ALERT SERVICE BULLETIN

412-23-192

MODEL AFFECTED: 412EP

SUBJECT: WIRE HARNESS INSTALLATION, MODIFICATION OF.

Figure 1 (Sheet 1 of 3) Location of possible low clearance or fouling condition.

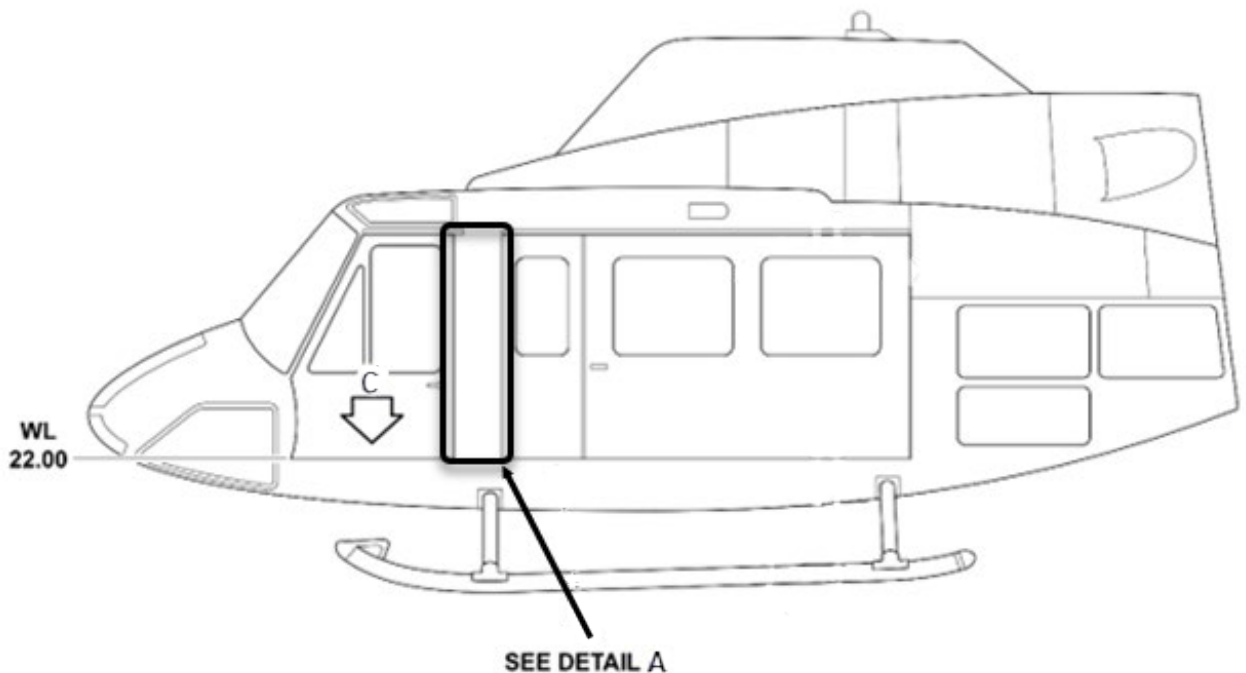
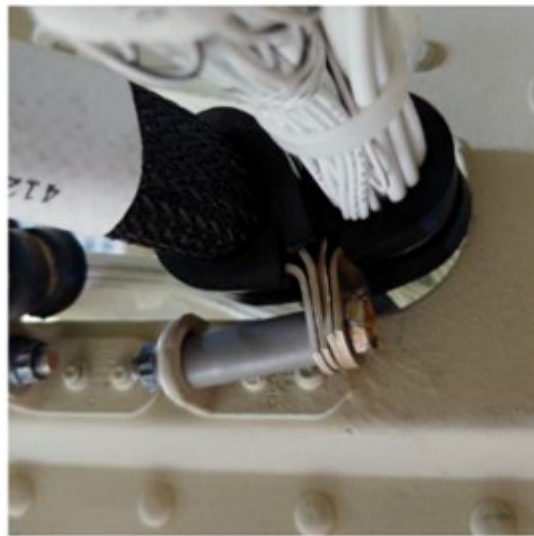
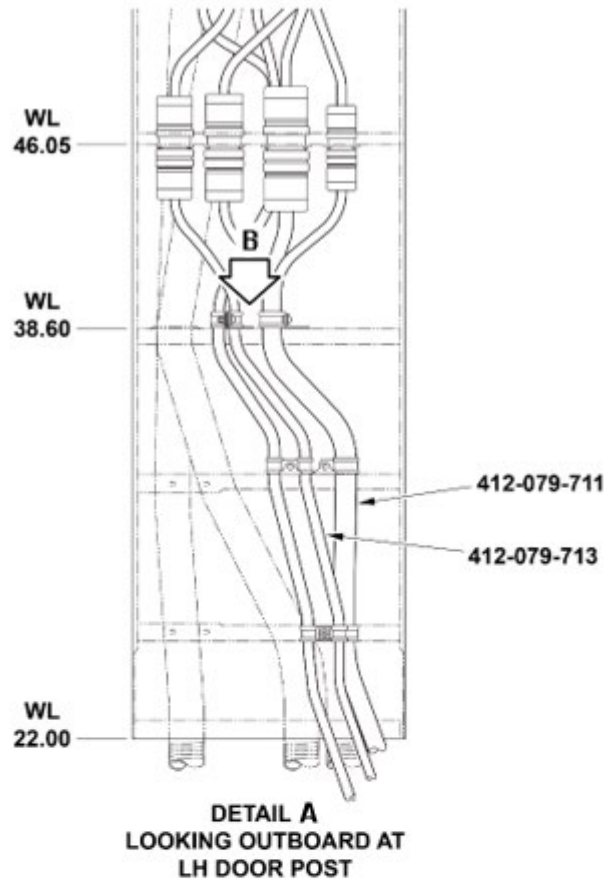
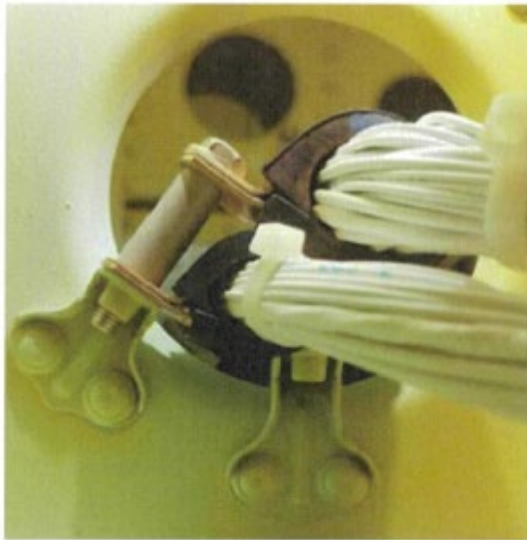
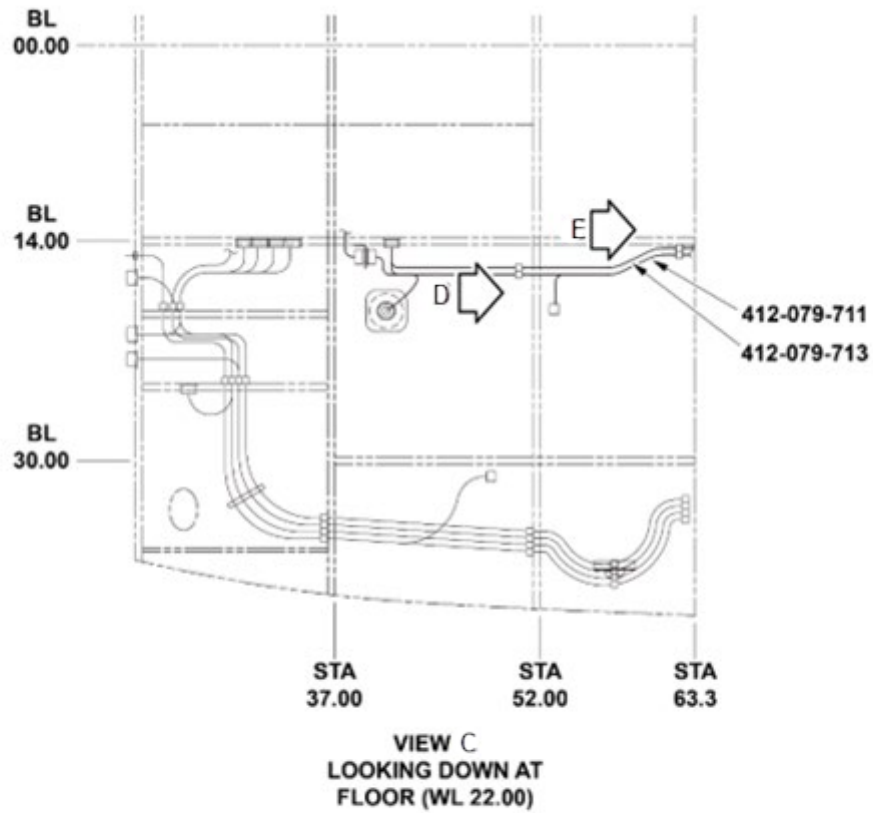
Bell has discovered a possible wire chafing conditions for the items describe herein. For the affected helicopters due to an incorrect installation, there is a potential wire chafing condition in the left-hand door post at water line (WL) 38.60. Helicopters equipped with the Emergency Float retrofit Kit 412-704-138-101 (BHT-412-SI-108) may also have a wire chafing condition below the floor (WL 22.0) at STA 52.0 and STA 63.3.

1. Prepare the helicopter for maintenance.
2. Refer to Figure 1, Detail A and View B, gain access to clamping arrangement in the left-hand door post at Water Line (WL) 38.60.
3. Inspect the wire harness (412-079-711) in the left-hand door post at WL 38.60 (View B) clamping arrangement for chafing damage with the structure.
4. Refer to Figure 1, View C, View D and View E, gain access to clamping arrangement below the floor (WL 22.0) at STA 52.0 and STA 63.3.
5. Inspect the wire harnesses (412-079-711 and 412-079-713) below the floor (WL 22.0) at STA 52.0 and 63.3 (View D and View E) clamping arrangement for chafing damage with the structure (lightening holes).

6. If damage or fouling with adjacent structure is found at steps 3, or 5 above it must be repaired before further flight. Repair damage and accomplish Part II of this ASB immediately.
7. If no damage or fouling with adjacent structure is found the helicopter can remain in service until Part II of this ASB is accomplished.
8. Make an entry in the helicopter logbook and historical service records indicating findings and compliance with Part I of this Alert Service Bulletin.

Figure 2 (Sheet 1 of 3) Location of possible low clearance or fouling condition at the left door post.

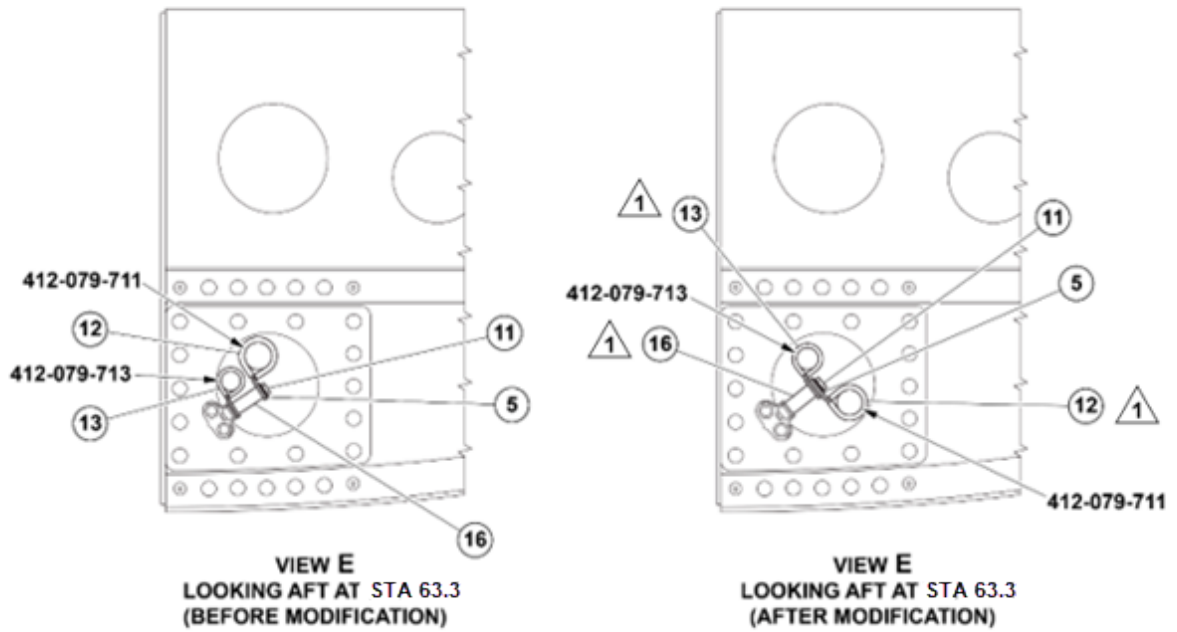
1. Prepare the helicopter for maintenance.
2. Refer to Figure 2, View A, gain access to clamping arrangement in the left-hand door post at Water Line (WL) 38.60.

3. Remove the existing clamping arrangement; nut (1, Figure 2, Detail B, Before Modification), spacer (2), clamps (3 and 4), washer (5) and screw (6). Retain nut (1) and washer (5). Discard spacer (2), clamps (3 and 4) and screw (6).

4. Install new clamping arrangement; nut (1, Figure 2, Detail B, After Modification), spacer (7), clamp (8), washer (5) and screw (9) to secure the two branches of the wire harness (412-079-711) in the single clamp (8).

5. Inspect and confirm wire harness (412-079-711) does not contact the structure at WL 38.60
6. Refer to Figure 2, View C, View D (Before Modification) and View E (Before Modification), gain access to clamping arrangement below the floor (WL 22.0) at STA 52.0 and STA 63.3.
